Access Compliance Report

Public Rights-of-Way

| Intersection ID: N/A | Main Street: STONEHAM CT | Cross Street: CROSS POINT CIR | Location: NE |
| ADA ID: 21A62FC860F4 | Ramp Type: PerpDiag | Initial Pass/Fail: Fail | Overall Compliance: No |

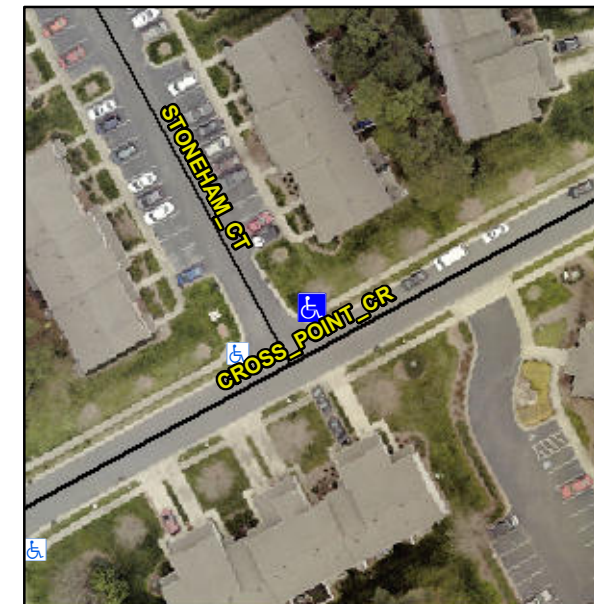
R304.5.1, R304.2.2

| Compliance | Description | Data | Compliance | Description | Data |
|------------|-----------------------|------|------------|-----------------------------|------|
| N/A | Ramp Length (in) | 50.0 | No | Ramp Slope (%) | 10.7 |
| No | Ramp Width (in) | 37.0 | Yes | Ramp XSlope (%) | 0.0 |

Remove & Replace Curb Ramp With Two New Directional Ramps or Equivalent.
